WINDERMERE FILING NO. 2 GRADING & EROSION CONTROL PLANS 7653 MARDALE LN. TRACT B, WINDERMERE FILING NO. 1 COUNTY OF EL PASO, STATE OF COLORADO

Sheet List Table	
Sheet Number	Sheet Title
1.0	COVER SHEET
2.0	INITIAL PLAN
3.0	INTERIM PLAN
4.0	FINAL PLAN
5.0	CUT & FILL PLAN
6.0	GENERAL NOTES
7.0	DETAILS
8.0	DETAILS
9.0	DETAILS
10.0	DETAILS
11.0	DETAILS

**WINDERMERE FILING NO. 2
GRADING AND EROSION CONTROL PLANS
EL PASO COUNTY, COLORADO
COVER SHEET**

1.0

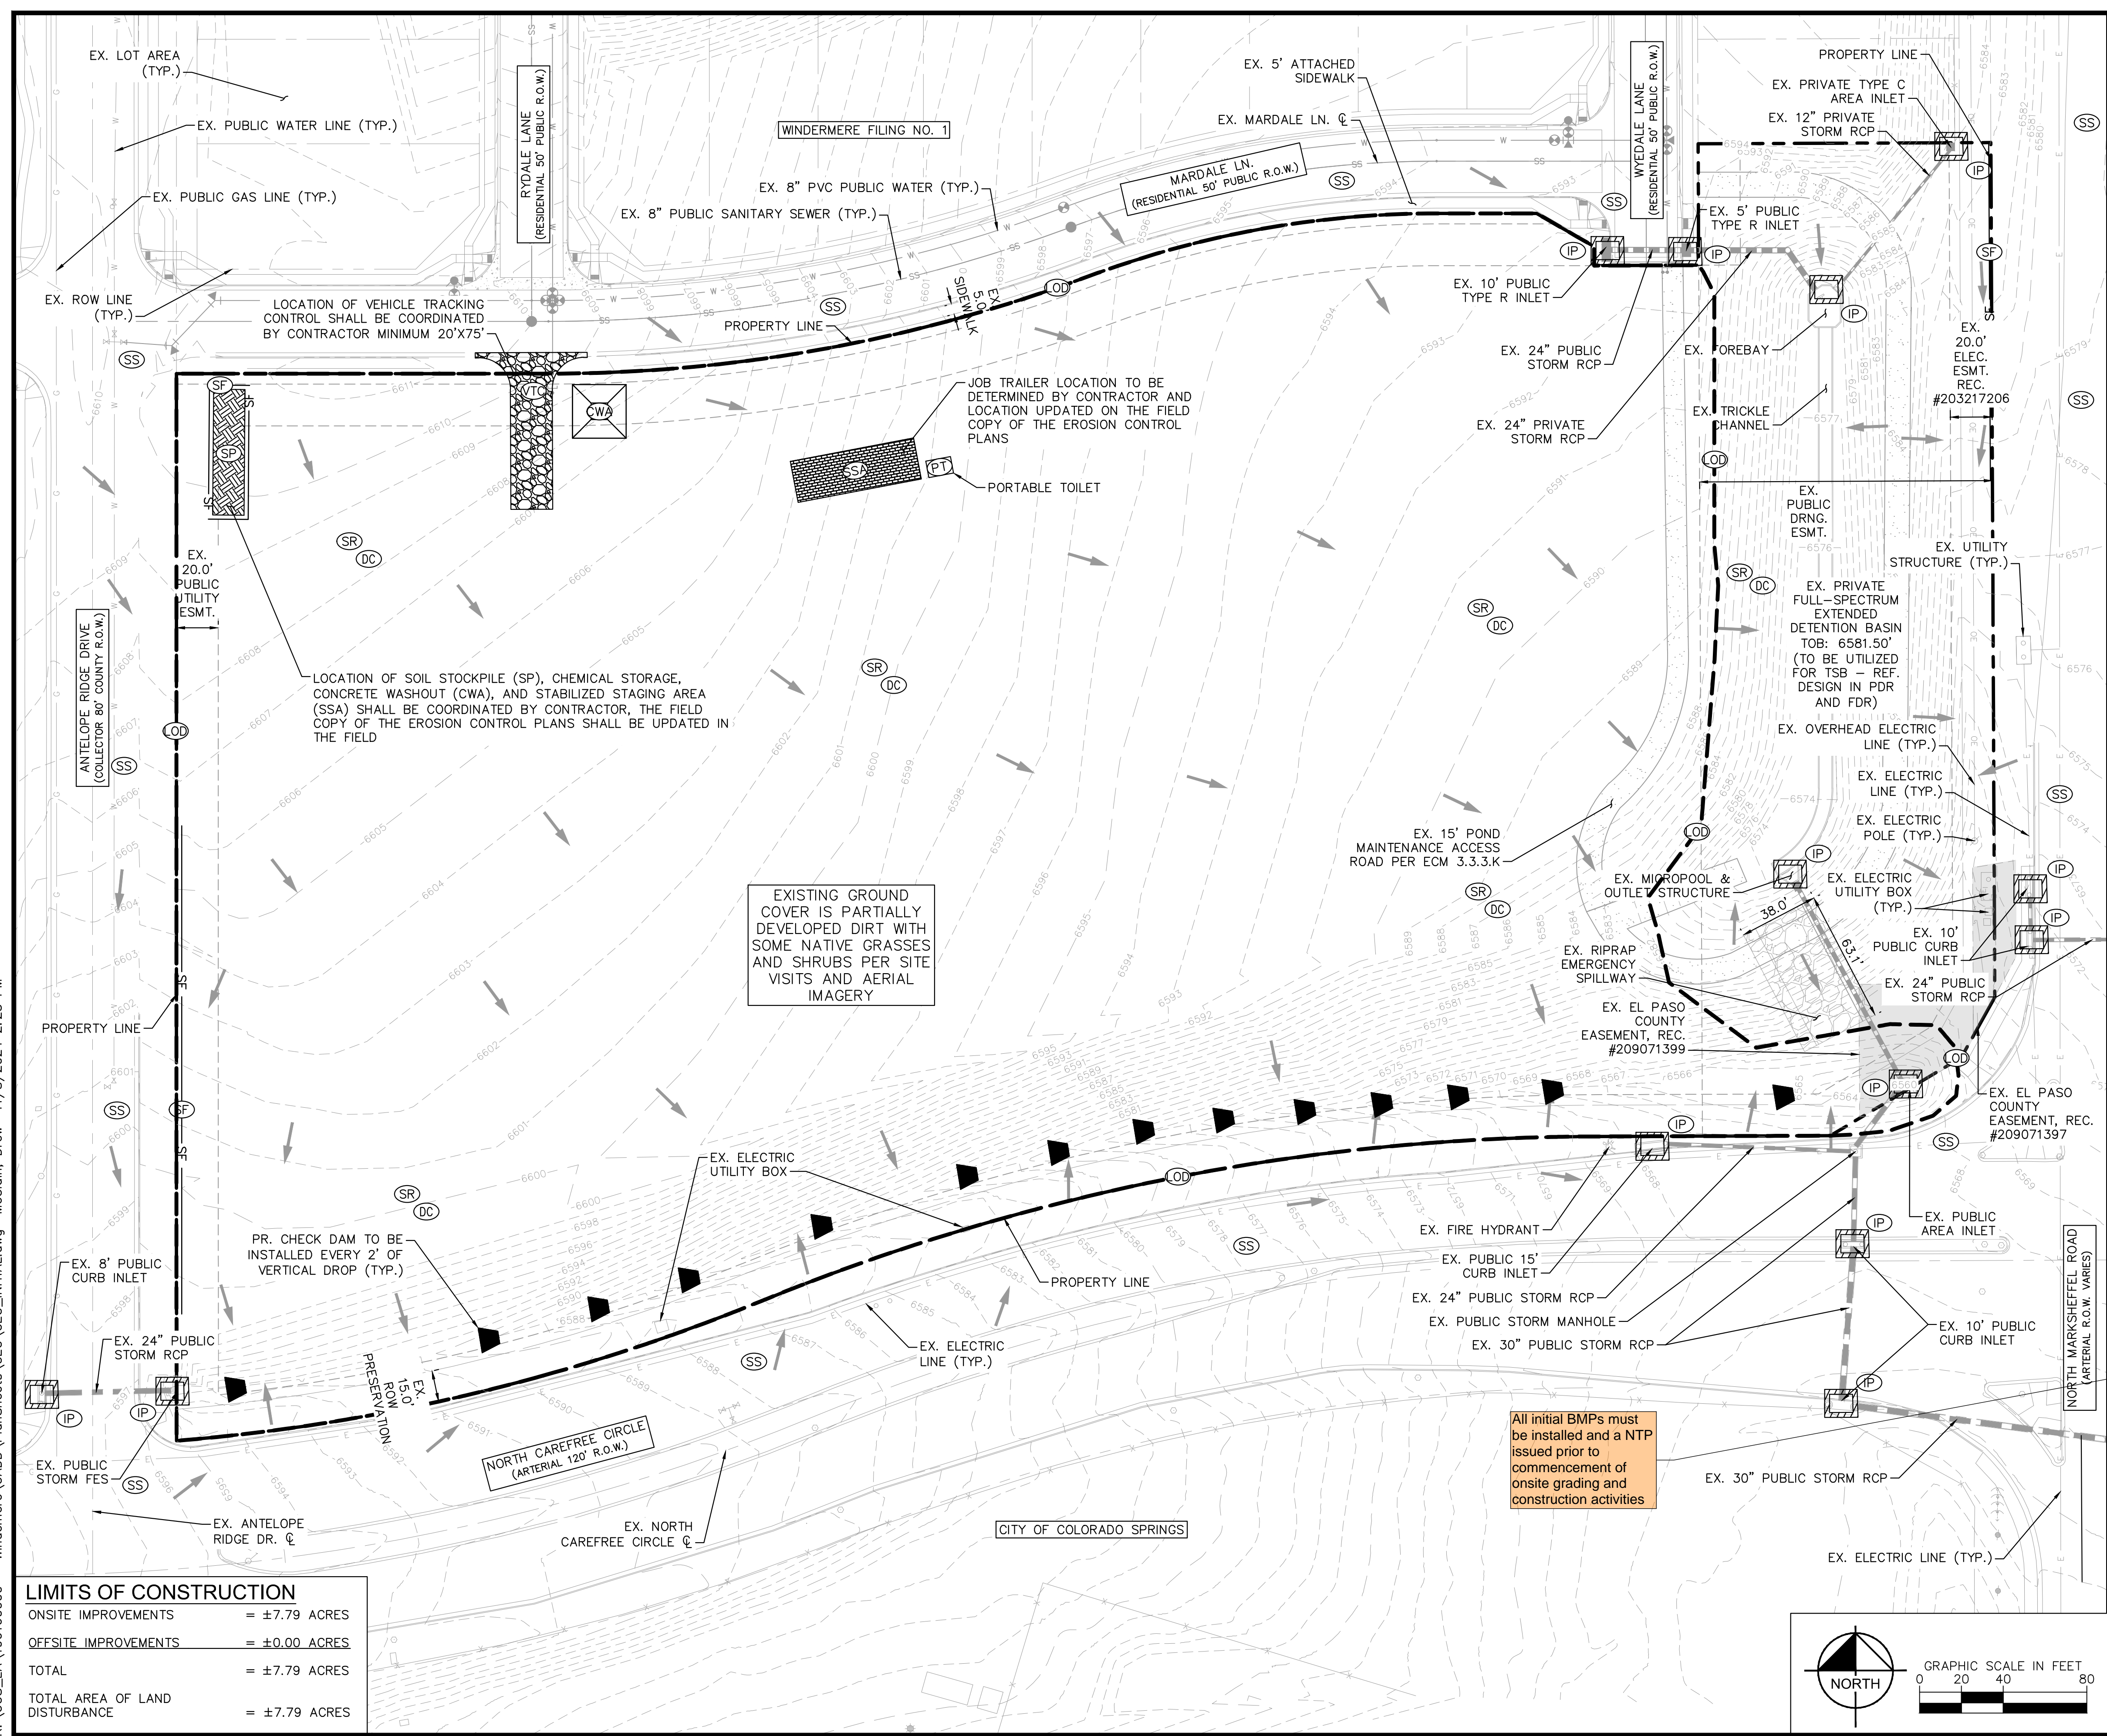
GEC Checklist Item 1 - please add a note about existing vegetation at the site.

To comply with the SWMP Checklist Item 17f, please add a note stating no batch plants will be utilized onsite.

SHEET
 4.0

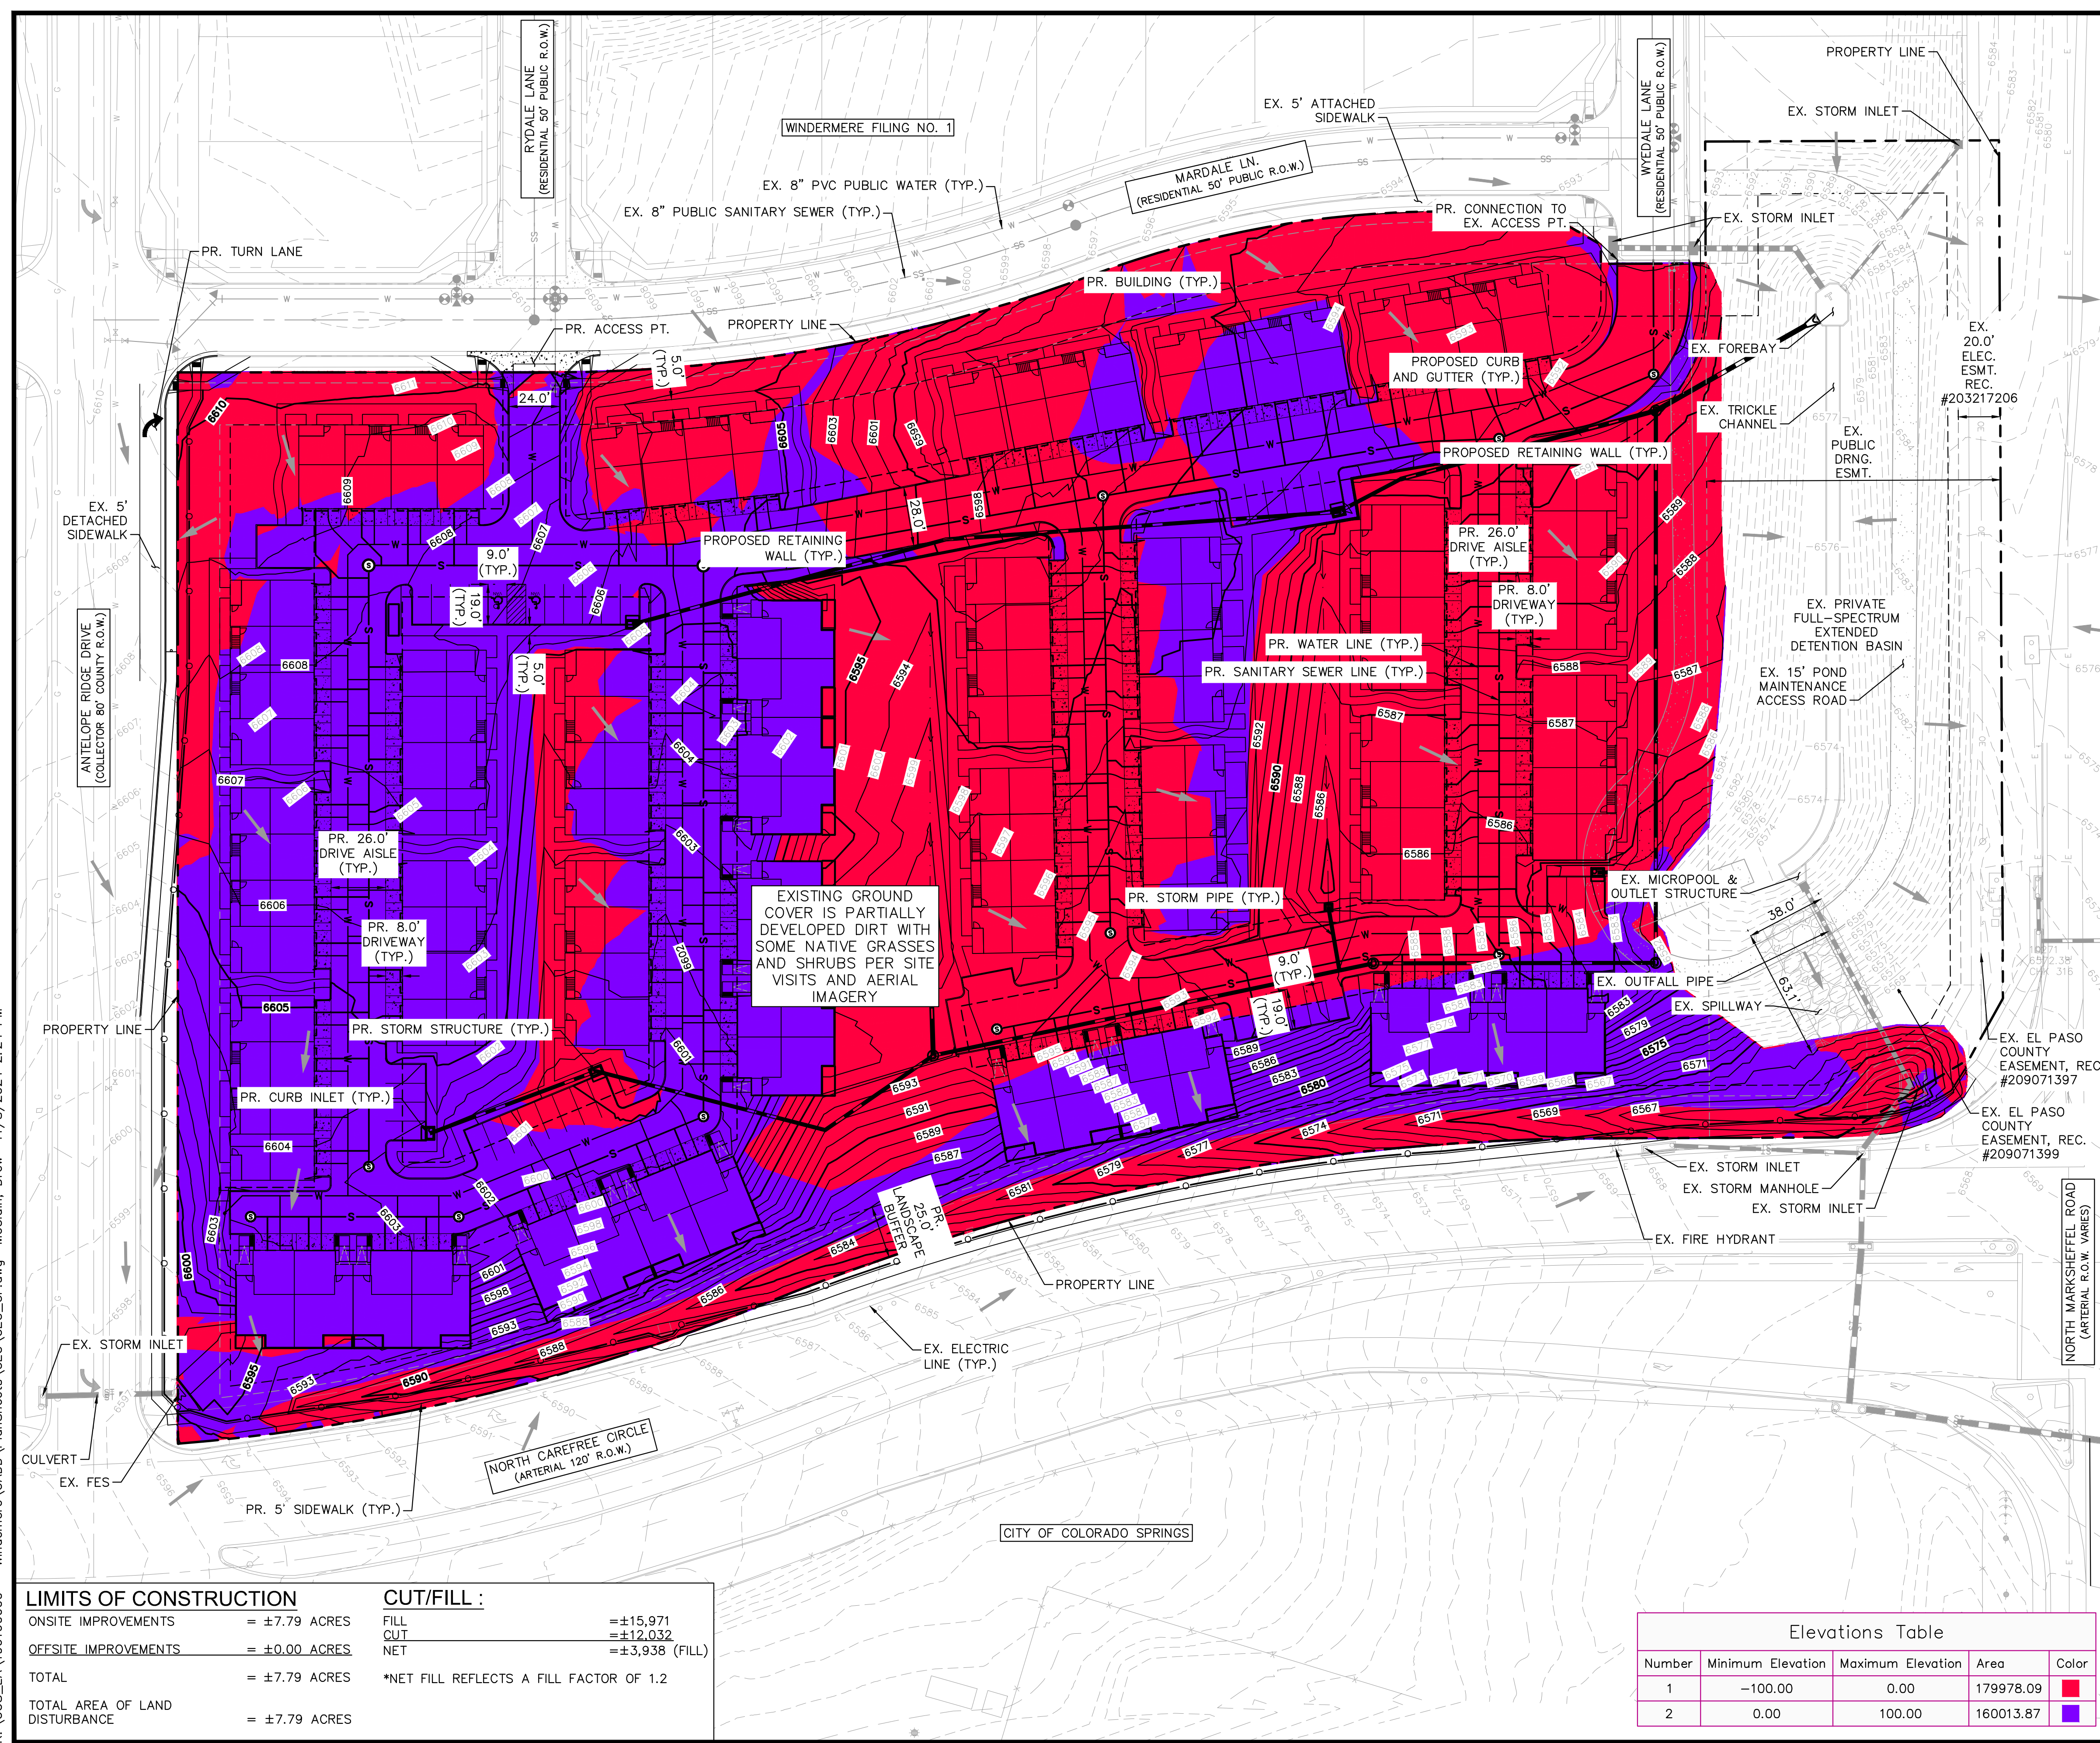
GEC Checklist Item v - Final stabilization is a requirement under the MS4 Permit and therefore needs to be reviewed and approved by the County Engineer. The landscaping plans are not approved by the County Engineer. Please add final stabilization to the Final GEC Plan sheet. It does not need to go into the same amount of detail as the Landscape Plans, the GEC just needs to show hatching for seeding/mulching, erosion control blanket, gravel, asphalt, etc.
